# Fax Transmission

Subject : Haven Lake Animal Hospital License Application  
Mail Control Number 143558

Mr. Thompson,  
The following answers are being provided to your questions received by e-mail today:

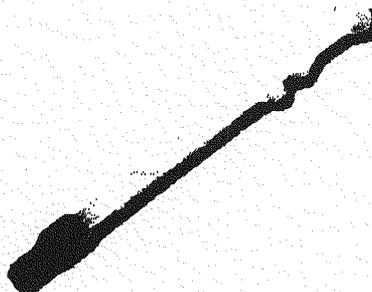
3. Please provide additional details on the pill gun device used to administer the doses.

The pill gun is basically a device that holds a capsule and allows the user to remotely insert the capsule down the throat of the animal without being bitten. One model looks like this:
